### REQUEST FOR TECHNICAL REVISION (TR) Importation of Inert Fill

File No.: M- 1992-054 Site Name: Ignacio Pit (aka La Boca Pit)  
County: La Plata TR# \_\_\_\_\_ (DRMS Use only)  
Permittee: LBCR, LLC (La Boca Canyon Ranch, Todd Fisher, Manager)  
Operator (If Other than Permittee): Contract: Crossfire Aggregate Services LLC  
Permittee Representative: Nathan Barton (WASTELINE, Inc.) 970-564-1380  
and Brian Abeln (Crossfire Aggregate Services LLC), 970-560-6757

# **IGNACIO PIT at LA BOCA CANYON RANCH** Attachment to 2025-0822 Technical Revision Showing location for placement of Imported inert fill in Area C.

**PERMIT #M-1992-054**

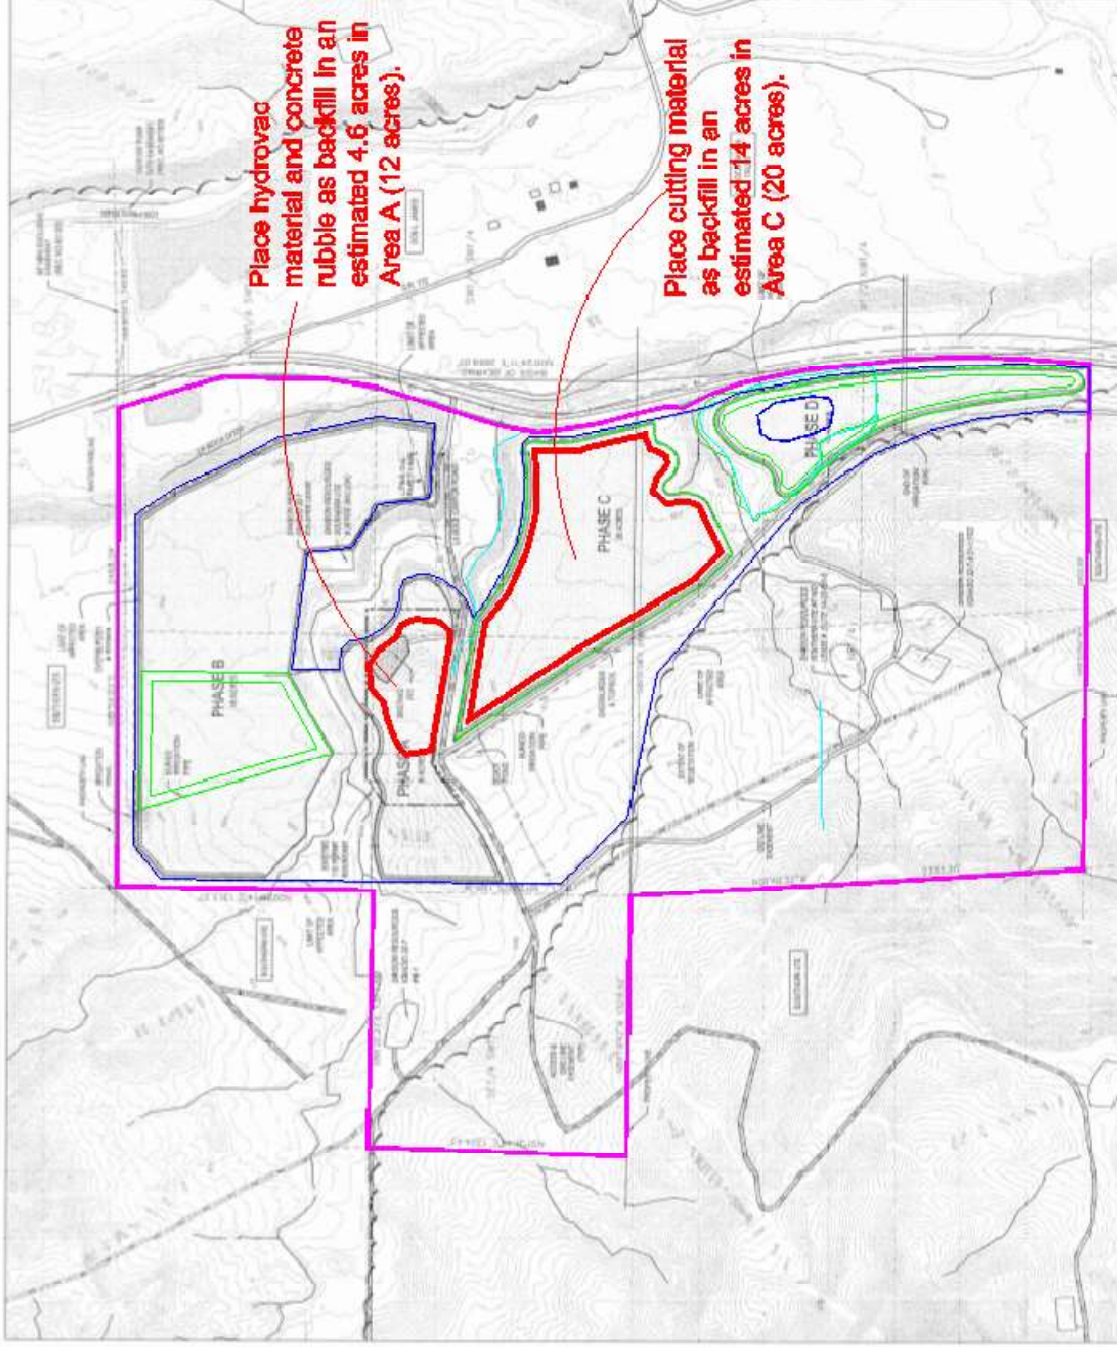
Enclosed is a map showing the proposed location of the inert material.

Item 2. (explained) Estimated based on anticipated activities to be supported, over a three-year period, and uncompacted volume for haul, to fill designated location on floor of Area C.

Notes: Excavation of Area C has ceased, and reclamation is ongoing, starting with the perimeter of the area, primarily to north, east, and south. Area C is a closed basin with no surface discharge, and

sloped to ultimately allow irrigation and a potential pond location (not part of reclamation plan). Outer slopes have been shaped and soil placed and seeded. Area to be filled is approximately 14 of 20 acres on floor, with good access off primary haul road with good traffic flow. Trucks bringing the imported material would likely otherwise have to deadhead to the pit to load construction materials for haul to project site.

Area A is a previously disturbed area with good access and has berms and terrain to allow tipping while preventing runoff and runoff of water from high-moisture materials, and allowing concrete to be buried at least three feet deep.
